PoE Plus
IEEE 802.3at
Classification Ad Hoc
Extended Classification Using
Two Classification Events

Clay Stanford
Linear Technology
July 17, 2007
San Francisco

Revised Specificiaton

Graphical Depiction of Problem

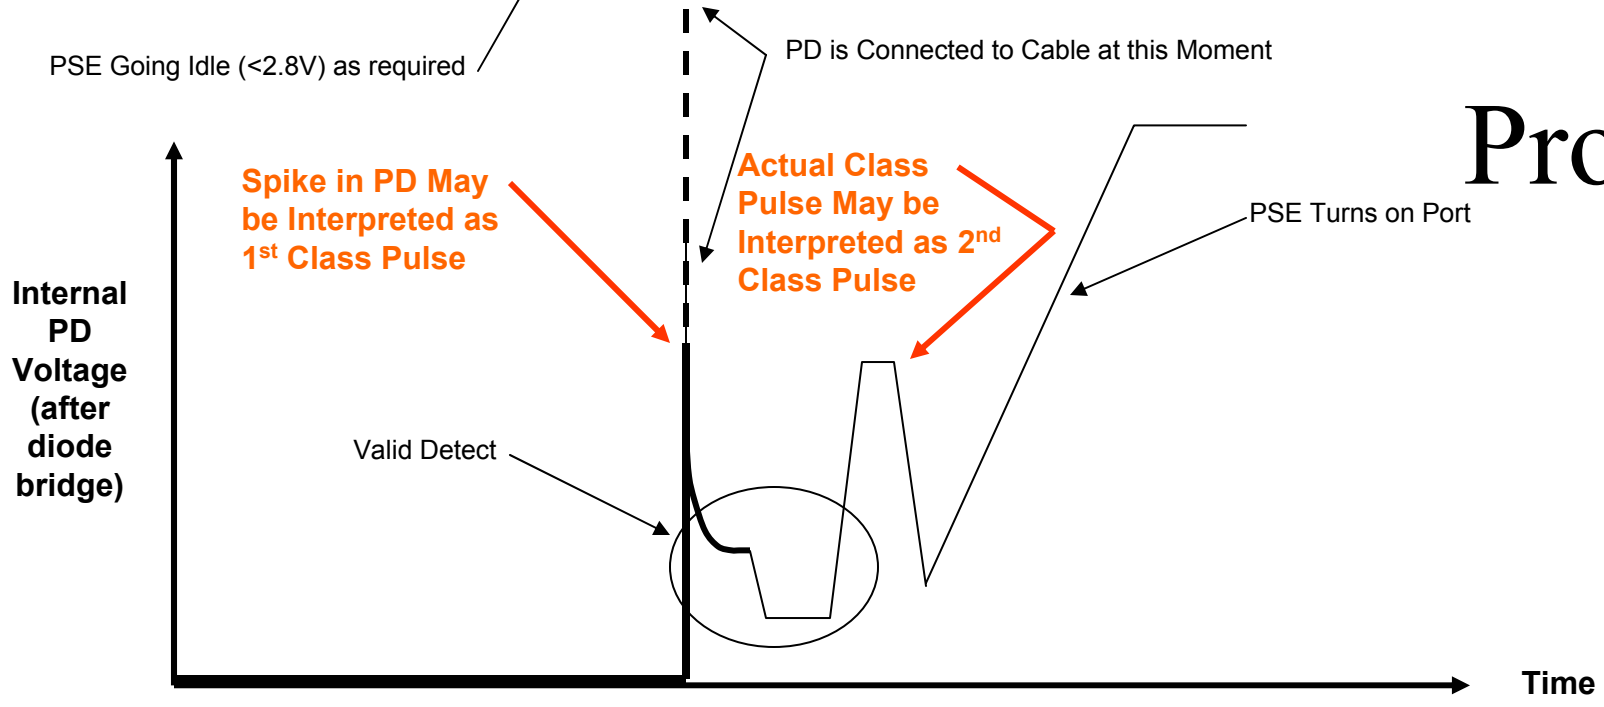
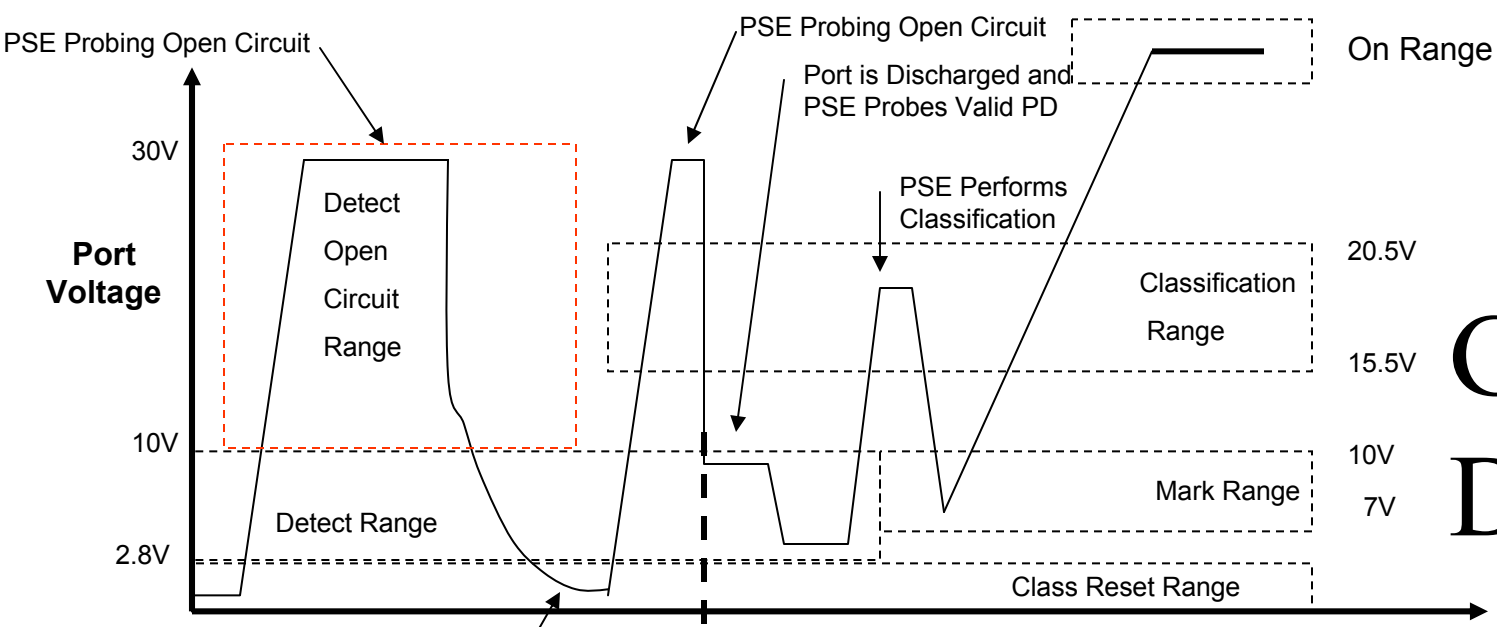
- The proposed 2-Event Classification protocol has a problem:
 - Using a compliant Type 1 (802.3af) PSE
 - Using a compliant Type 2 (802.3at) PD
 - When a Type 2 PD is plugged into a Type 1 PSE, possible for PD to incorrectly interpret waveform as the 2-Event Classification mechanism

- When a PSE is probing an open circuit, port voltage can go to 30V (Table 33-2, item 1)
- At the moment the Type 2 PD is connected to the cable, internal PD voltage can exhibit a spike similar to a classification pulse (refer to sample waveform)
- This spike can fool the PD state machine into thinking the first classification event has occurred
- After detection, Type 1 PSE may perform classification which would appear to Type 2 PD as the second classification event.
- Type 2 PD would incorrectly conclude that Type 2-Layer 1 PSE is present

- Do Not Allow 25K During Mark
 - PSE would fail detection during Mark period
 - PSE would return to Idle State ($V_{port} < 2.8V$)
 - PD State engine would be reset
 - No false Identification

Worst-Case Open-Circuit Port Model

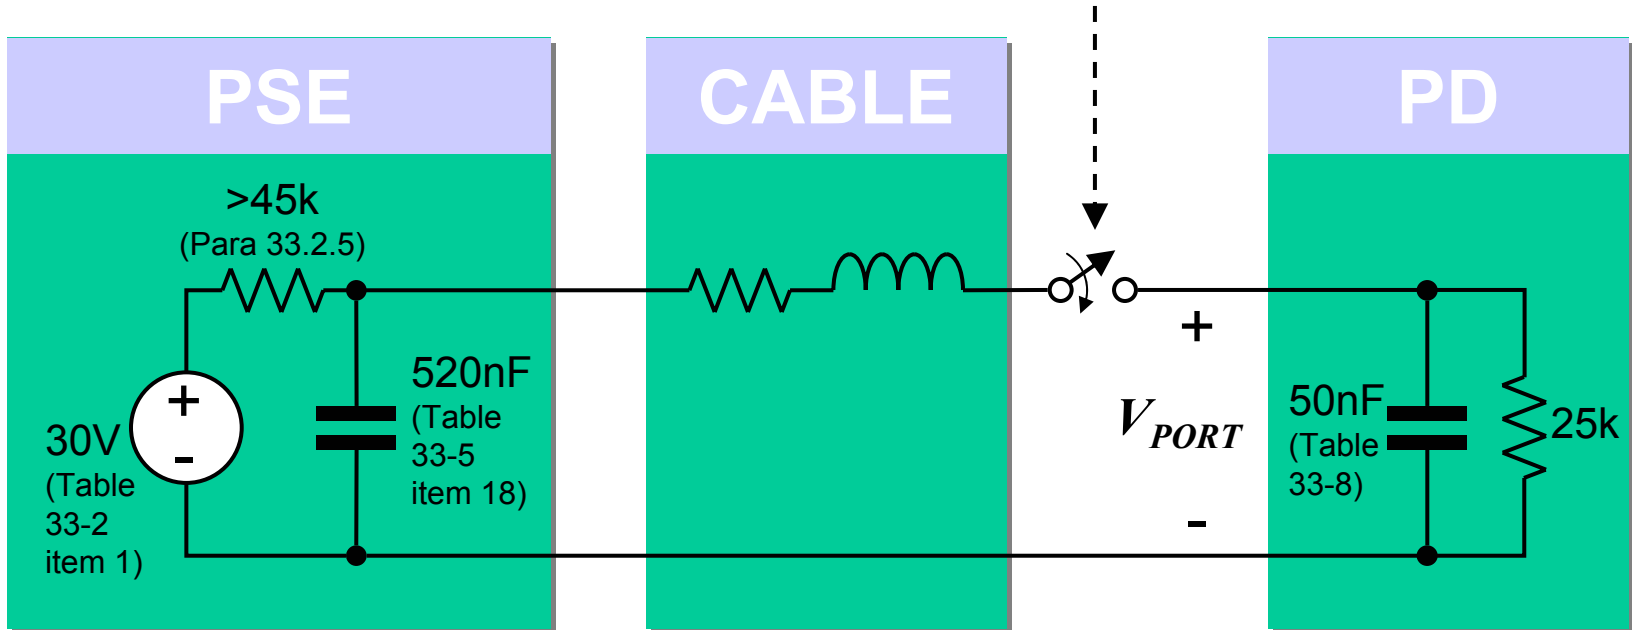
Switch closure represents PD being connected to the end of the cable

Experimental Waveform

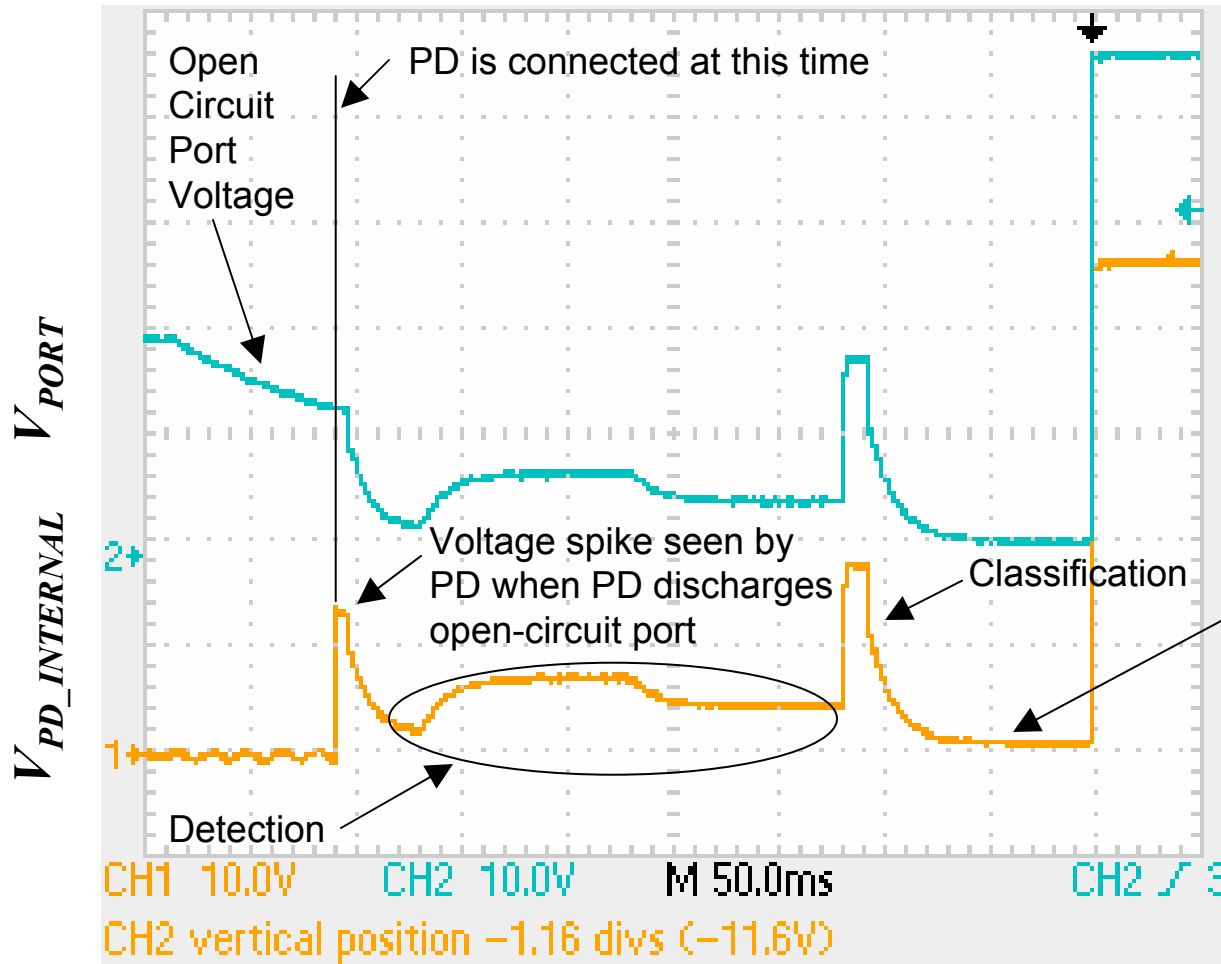
In this example, port goes to 0V which would reset the PD state machine. However, that is not required per IEEE 802.3af

PD State Machine Depends on PSE going to Idle State

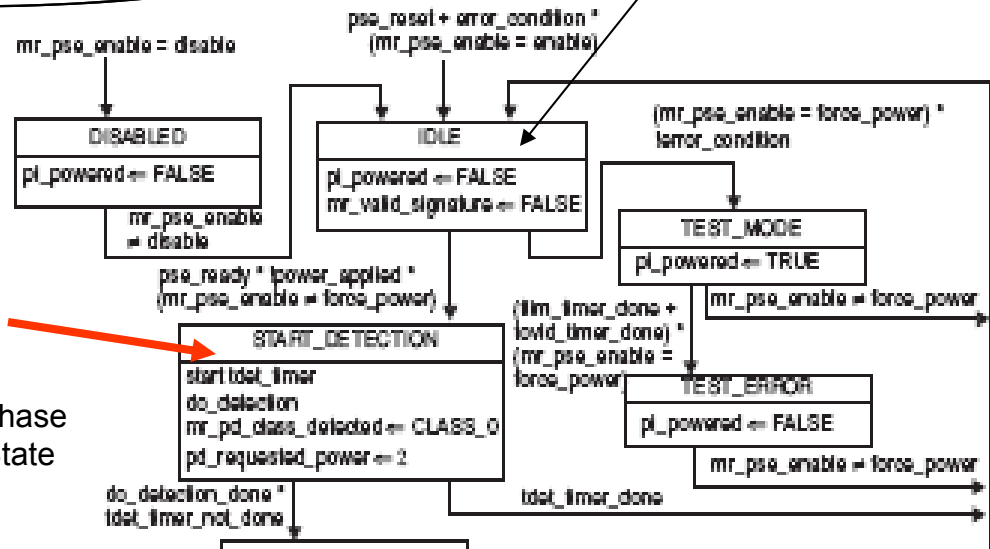
When plugging in PD, possible to Enter PSE State Diagram Here

If PD Plugged in after Idle State and Before Detection Phase 1 is complete, PD can see spike and may not see Idle State (used for PD Reset).

Expanded PSE Power-On State Engine

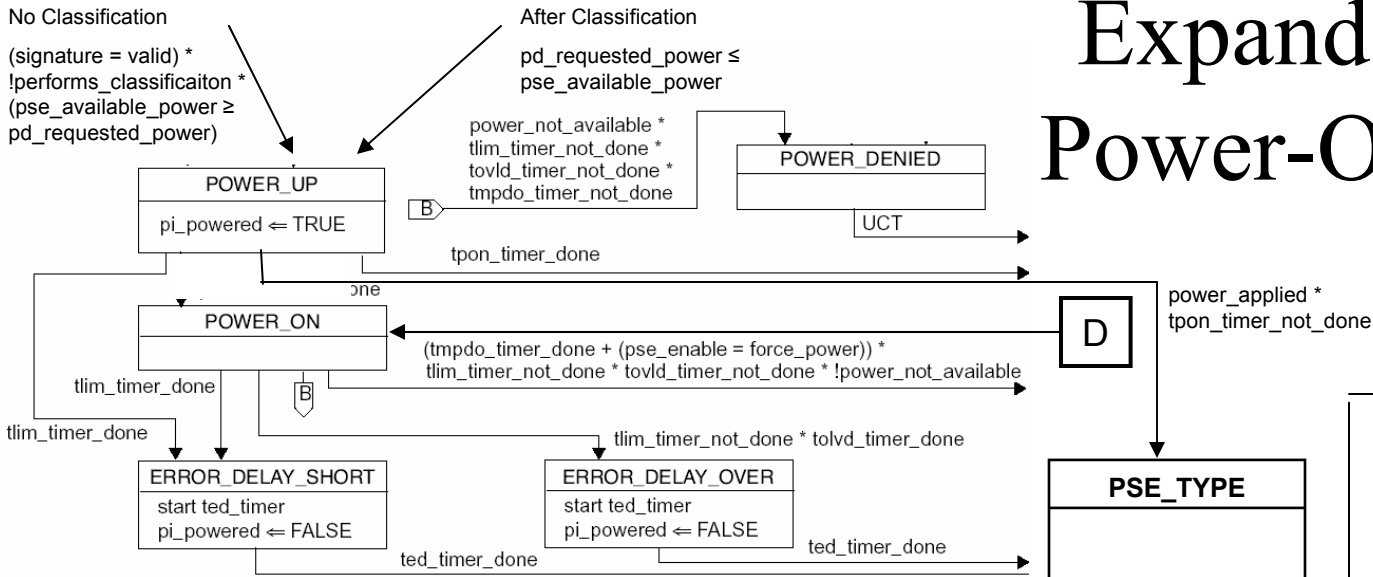
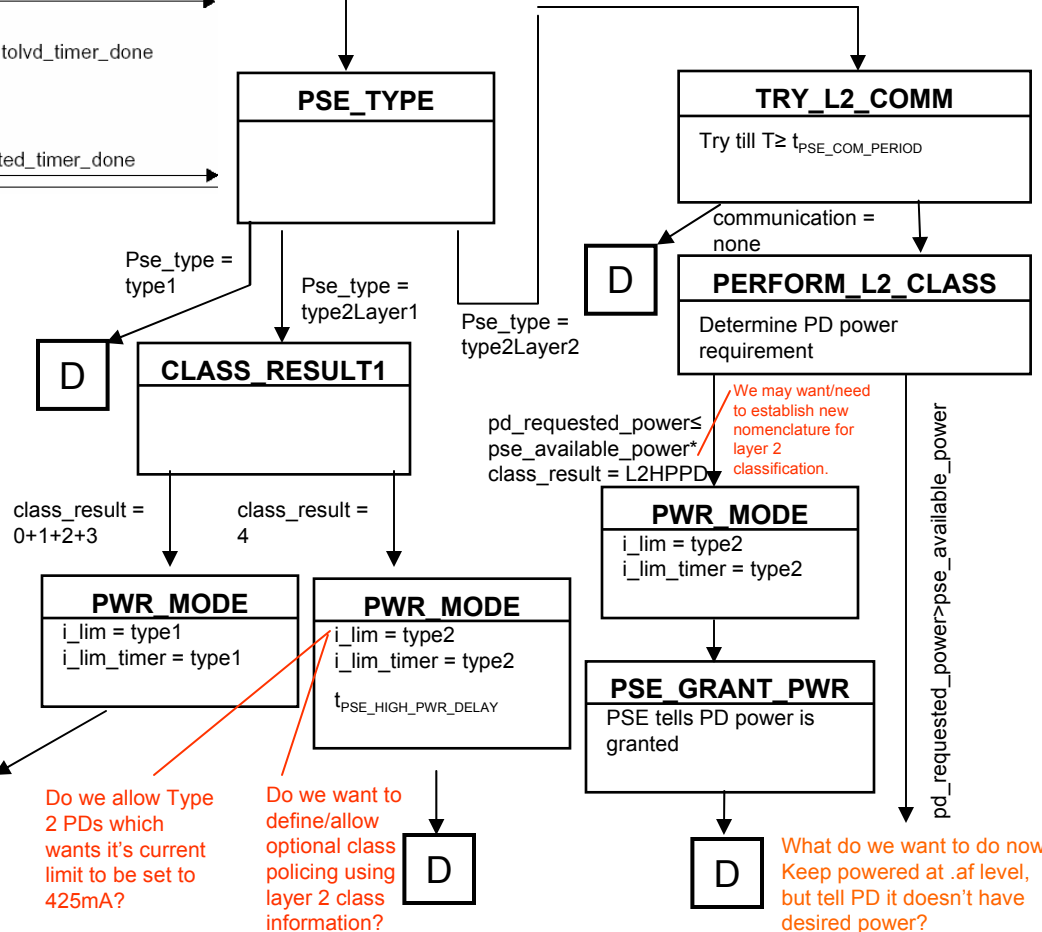
We need to define some new timing parameters. I would propose:

Determines the time between finish of inrush until PSE port is switched from type 1 (.af=425mA) to type 2 (.at == 780mA). It should be pretty fast, in case PD starts drawing big power soon after it receives voltage.

Forces PD to wait some period of time before using big power so PSE has time to switch from .af to .at mode.

$t_{PSE_HIGH_PWR_DELAY} = 100ms \text{ max}$

Defined from point $V_{port} \geq 50V$ until Current Limit is switched from type 1 (.af) to type 2 (.at) mode

$t_{PD_HIGH_PWR_DELAY} = 100ms \text{ min}$

Defined from point $V_{port} \geq 41V$ until PD draws > 12.95W

$t_{PSE_COMM_PERIOD} = 5sec \text{ min}$

Defined from point $V_{port} \geq 50V$ until PSE gives up establishing communication with layer 2 PD. After this point, PSE assumes PD is type 1 PD. Needs to be long enough to give PD time to boot up and establish communication.

$t_{PD_COMM_BOOTUP} = 4sec \text{ max}$

Defined from point $V_{port} \geq 41V$ until PD must be ready to communicate with PSE on layer 2. We need input from system vendors on this!
